HISTORIC AND DESIGN REVIEW COMMISSION

HDRC CASE NO: 2025-090
ADDRESS: 910 E SOUTHCROSS BLVD
LEGAL DESCRIPTION: NCB 7665 LOT SW 200 OF 4 & NE IRR 118.4 OF SW IRR 233. 4 OF C & W IRR 93 OF 15
ZONING: I-1
CITY COUNCIL DIST.: 3
DISTRICT: Mission Historic District
APPLICANT: Edward Hernandez/Nirvana Architecture Studio
OWNER: Isarael Ramirez/LIDS CHRISTIAN CENTER INC
TYPE OF WORK: Final Approval - New Construction of 10,000 sf church
APPLICATION RECEIVED: April 9, 2025
60-DAY REVIEW: June 8, 2025
CASE MANAGER: Caitlin Brown-Clancy

The applicant is requesting a Certificate of Appropriateness for approval to construct a new 10,000 sf building housing an auditorium, classrooms, and various auxiliary spaces on the existing campus of LIDS Christian Center at 910 E Southcross Blvd and site work consisting of a master parking and landscaping plan.

1 FRONT ELEVATION
SCALE: 1/8" = 1'-0"

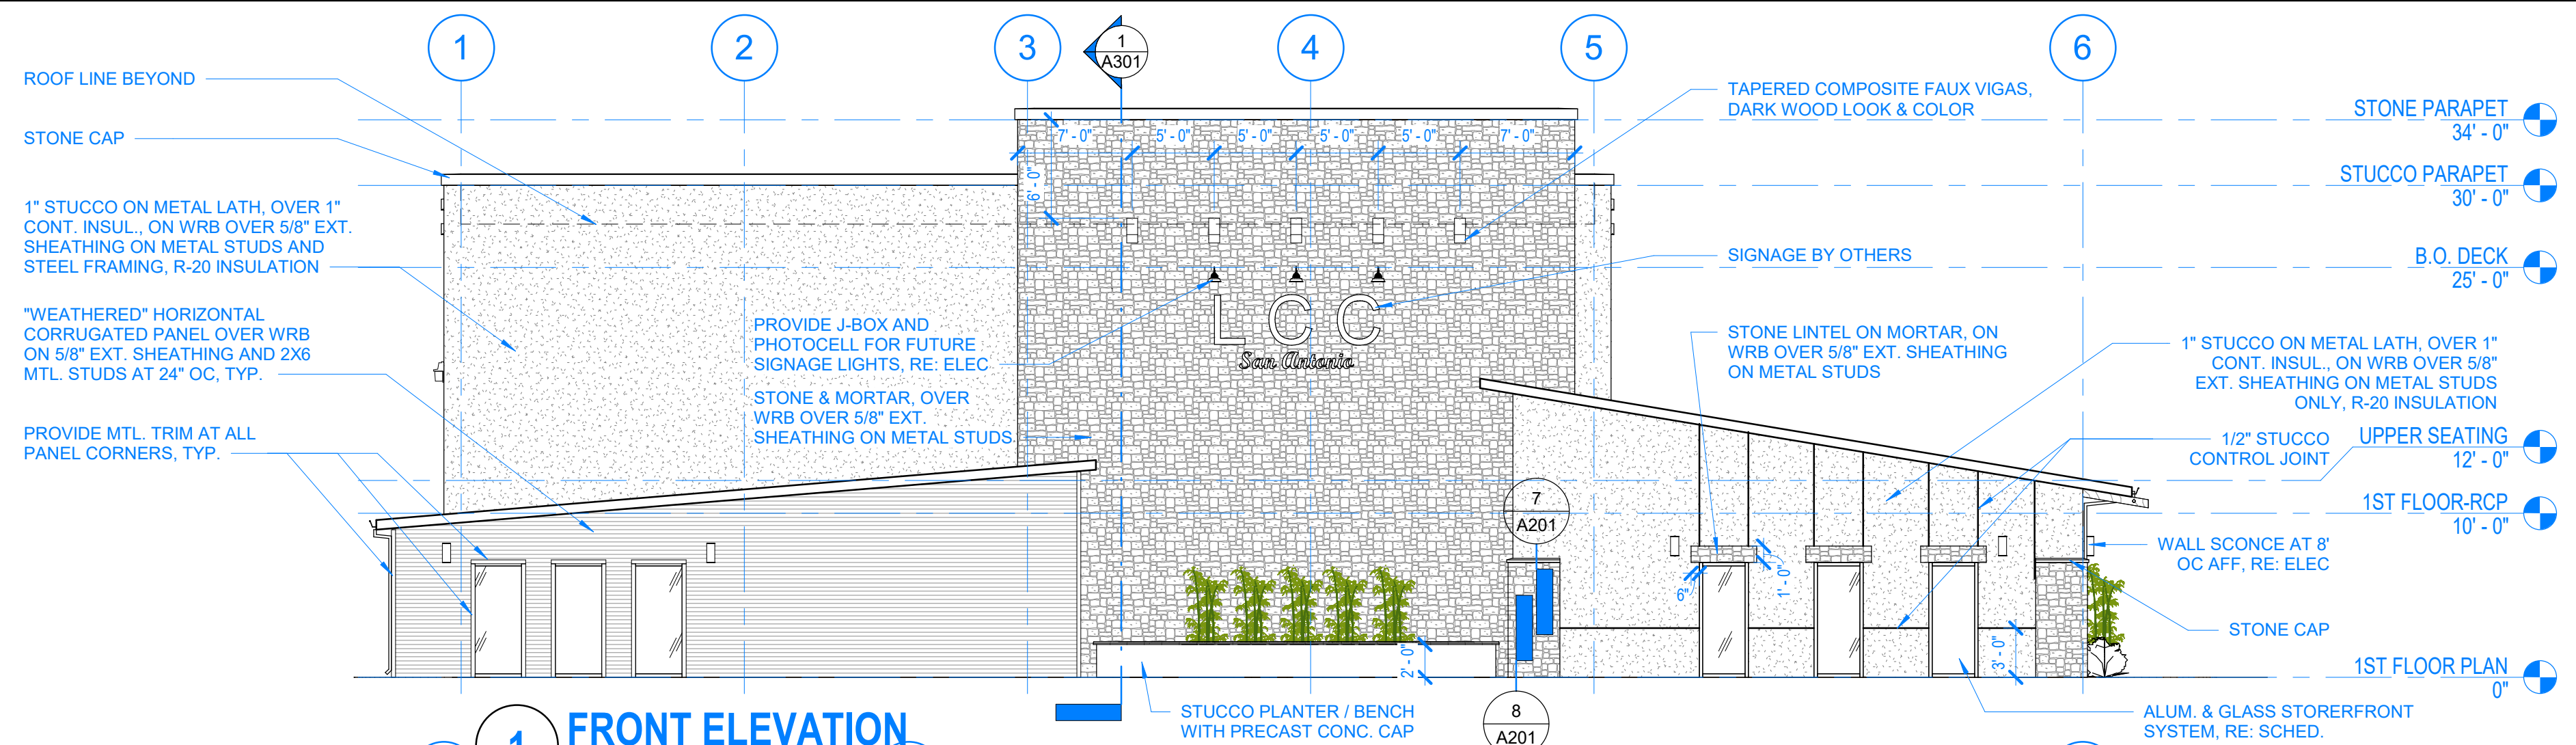
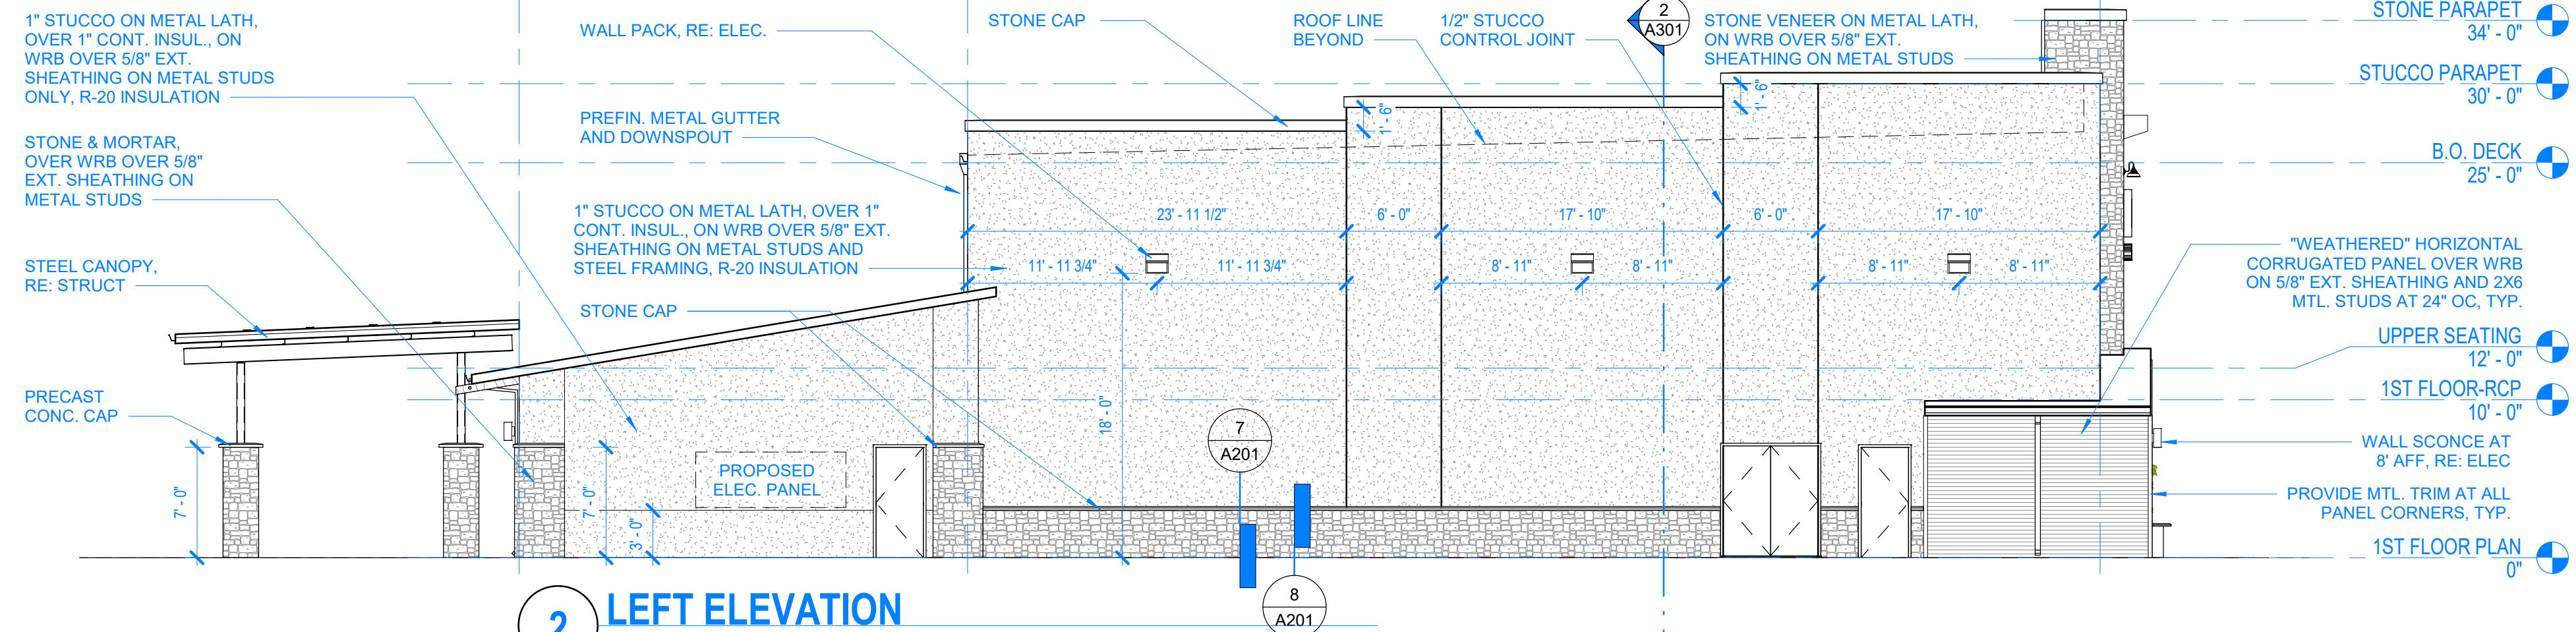
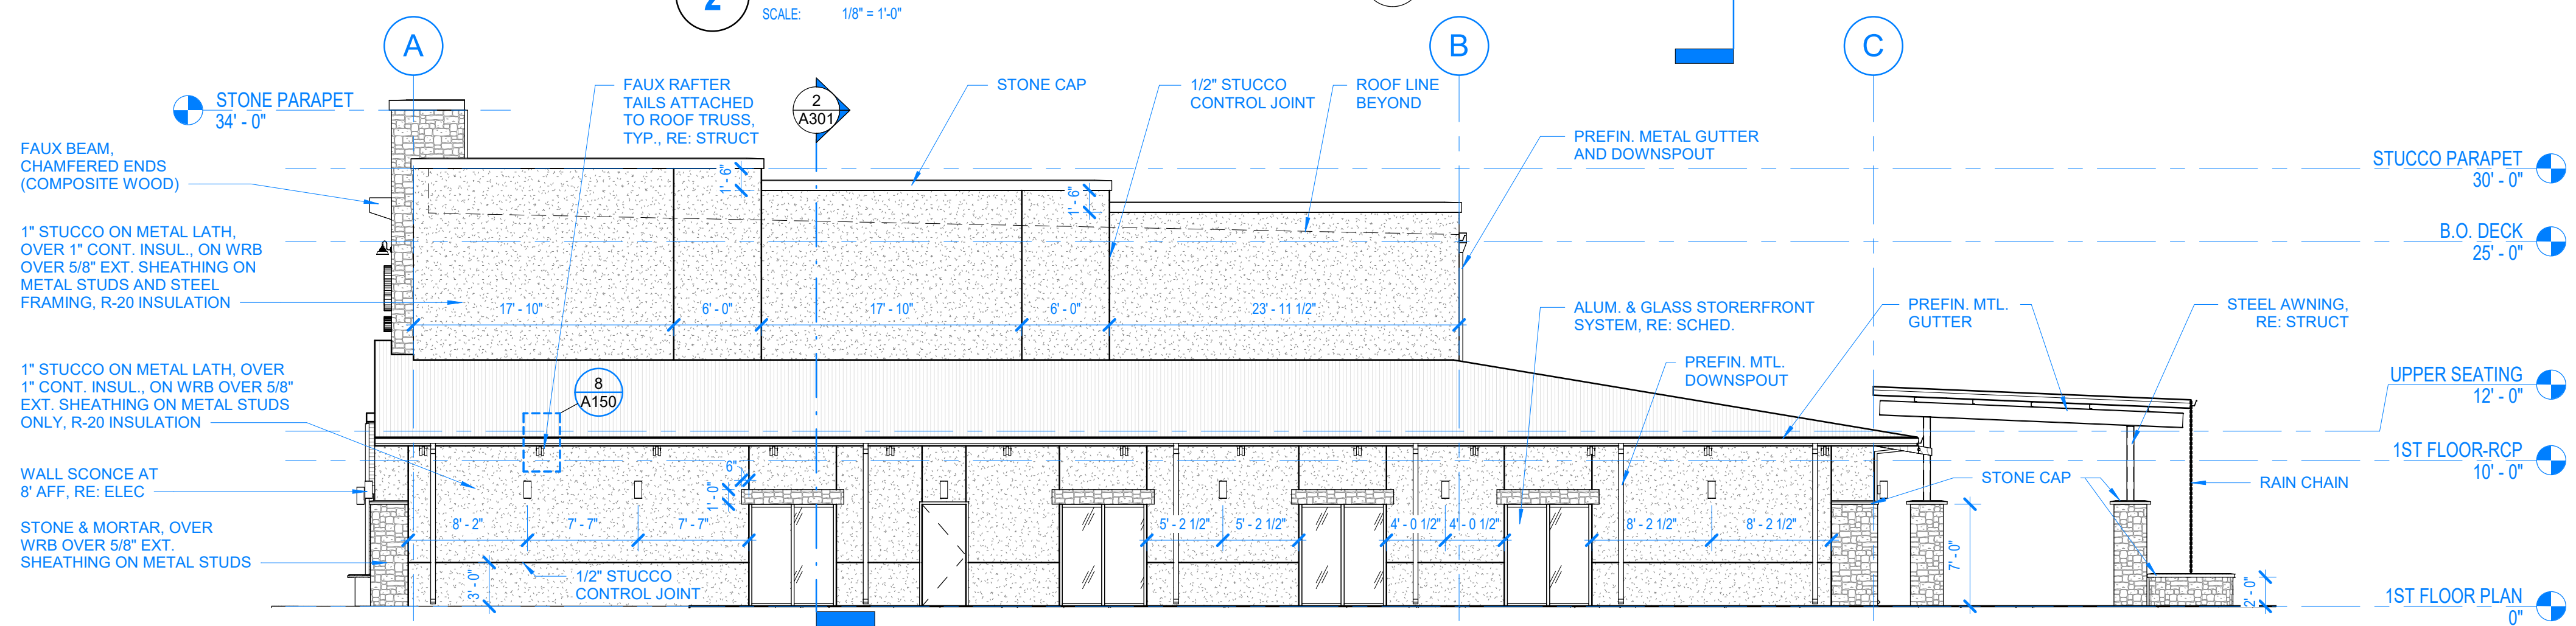
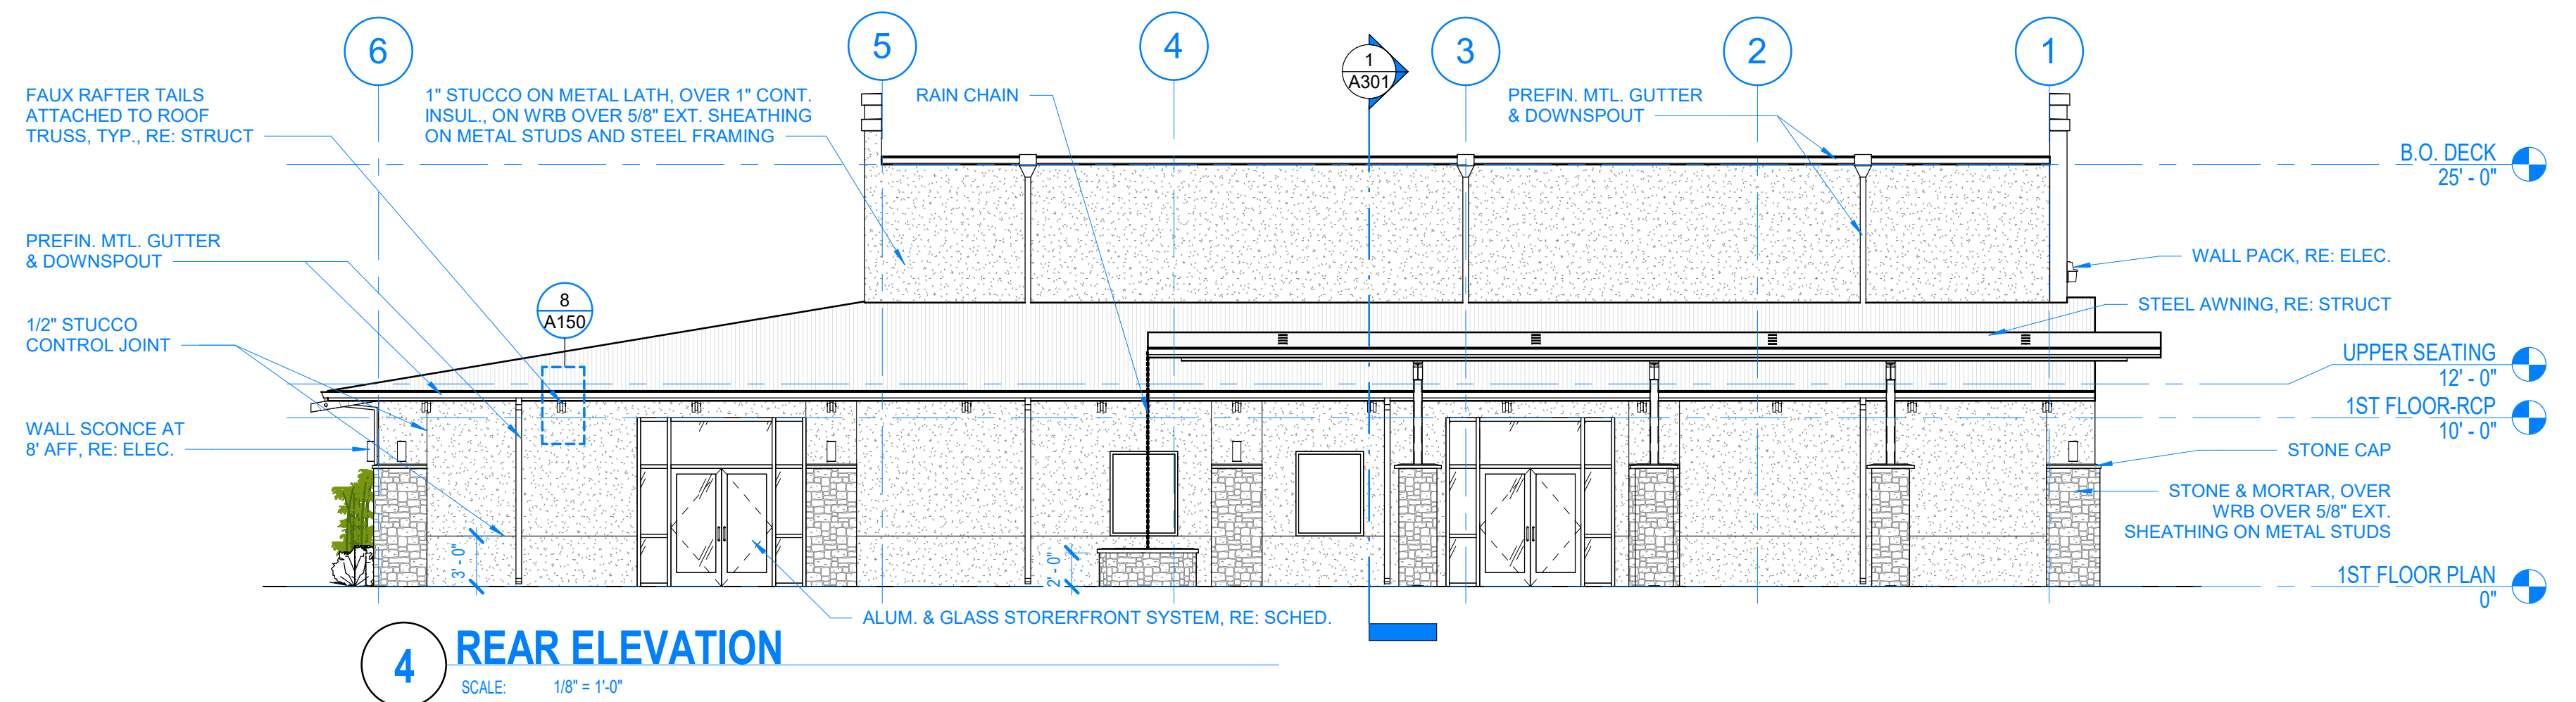
- i. **MASS, SCALE, FORM** – The applicant is requesting to construct a building whose primary façade features a hierarchical, massive, central form flanked by a secondary form to the West and a tertiary form to the East. The design calls for a transition in height of 32’0” at the highest roof projection of the ROW façade to 18’0” at the rear façade. The applicant utilizes transitions, material changes, and surface reliefs/control joints to provide interest to an otherwise monolithic expanse. Guideline 3.B.i states that Wall planes and fenestration patterns should be organized to yield facades that appear monolithic and enduring while still allowing for visual interest through breaks in scale and pattern. Staff finds the proposed form and mass consistent with the Guidelines particularly given the language of the adjacent structures to the property.

- j. **ROOF FORM** – The applicant has proposed a primary form consisting of a flat roof with a parapet wall punctuated by a taller parapet which projects 4’0” above the aforementioned flat roof with parapet. This central form is flanked on either side by a secondary form to the West and a tertiary form to the East both of which feature a shed roof form. Guidelines 3.C.i and ii state that a flat roof with a parapet wall is recommended as a primary roof form for all commercial buildings. Parapets may vary in height to articulate individual wall planes or programmatic elements such as entrances. Additionally, secondary roofs should utilize traditional forms such as a hip or gable and should establish a uniform language that is subordinate to the primary roof form. Contemporary shed roofs may be considered on a case-by-case basis as a secondary roof form based on the design merit of the overall proposal and the context of the site. Staff finds the proposed roof forms consistent with the Guidelines.

- m. **WINDOWS** – At this time, the applicant has not submitted exact window specifications. The drawing indicate use of a typical storefront fenestration system on the primary, rear and Western facades. Staff finds the applicant should install windows that meet the Standard Specifications for Windows in New Construction and that the applicant should submit product specifications for review prior to returning the HDRC for final approval.
